**DEPARTMENT OF TRANSPORTATION  
STATE OF GEORGIA**

**FILE:** NHS-0007-00(386) & NHS-0000-00(762) Lowndes **OFFICE:** Engineering Services  
P. 1, Nos.: 0007386 & 0000762  
I-75 Interchange Improvements

**SUBJECT: IMPLEMENTATION OF VALUE ENGINEERING STUDY ALTERNATIVES**

### **Subject: Responses to Value Engineering Study**

Bridge #2

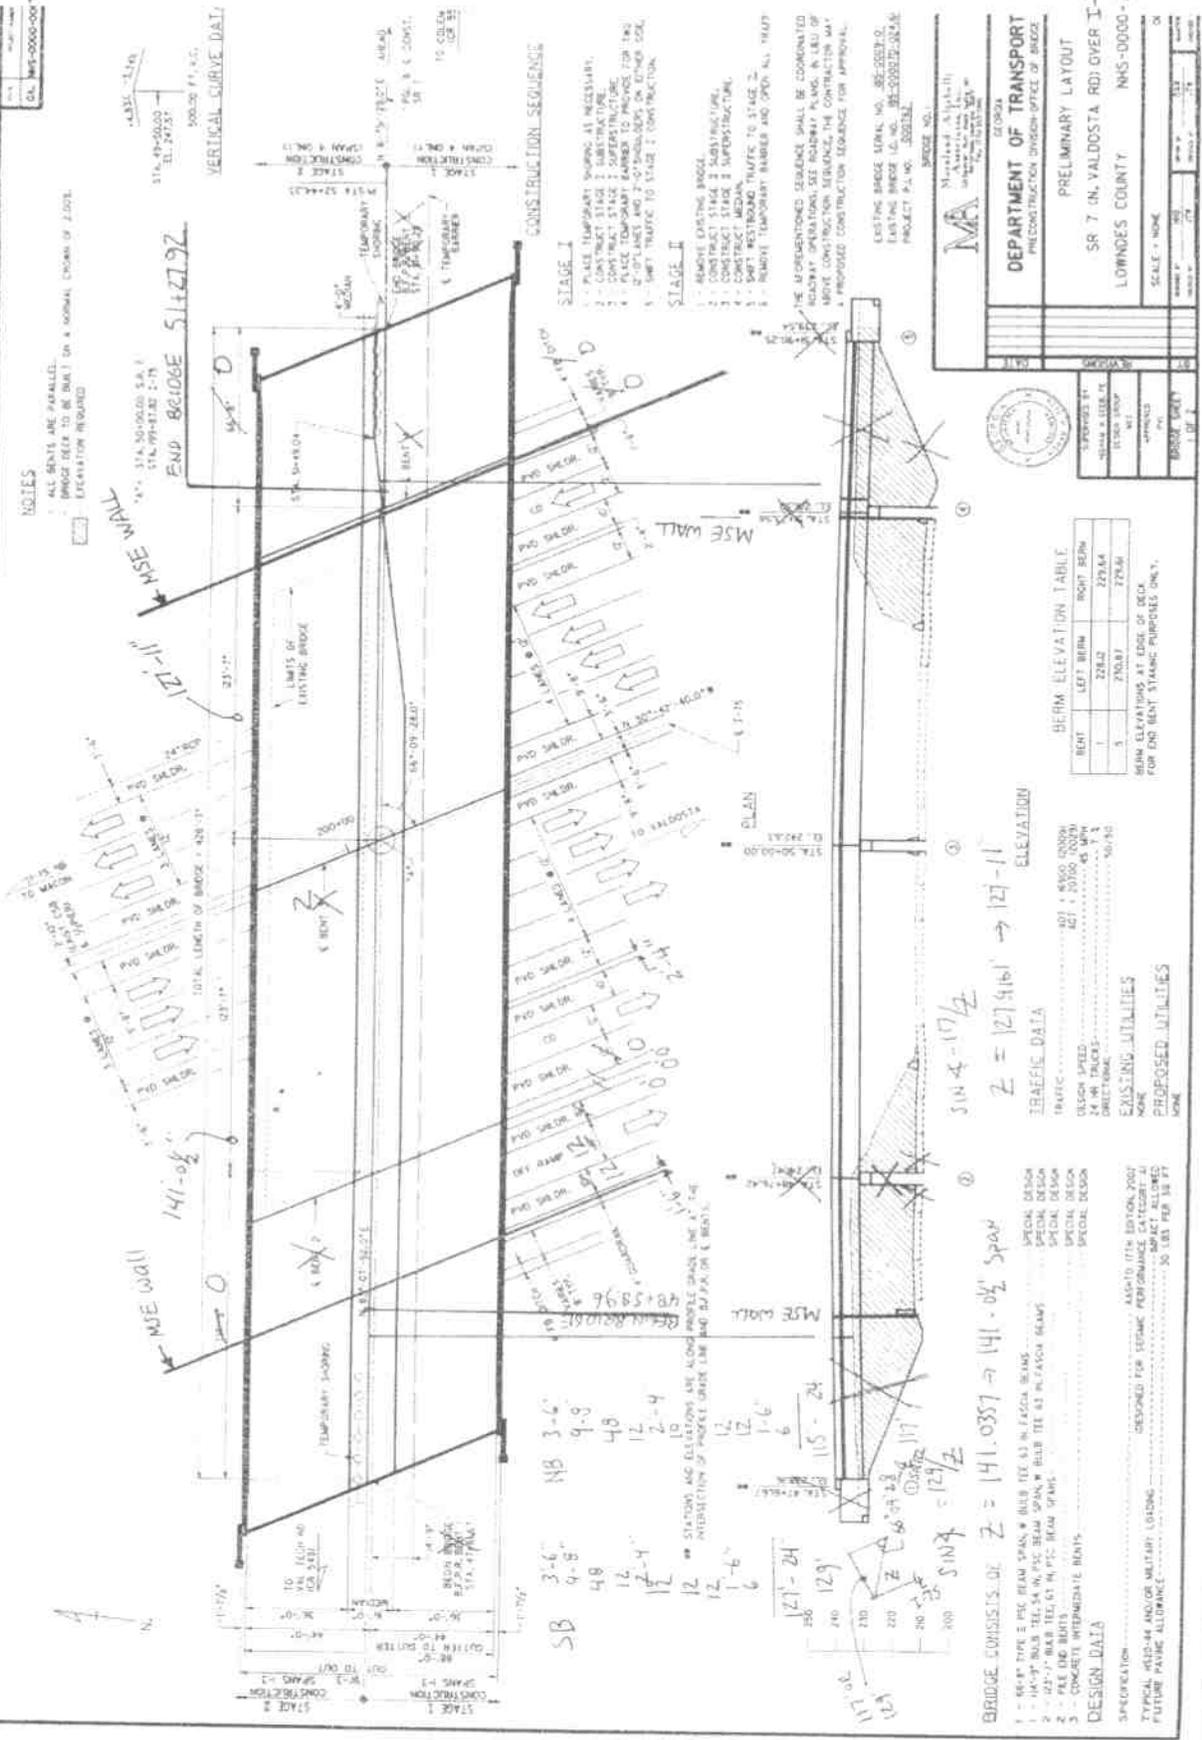
Attached, as requested in our morning phone conversation, is the cost analysis for the four span with 2:1 end rolls versus a two span with MSE walls for the SR 7 (N Valdosta Road) bridge over I-75.
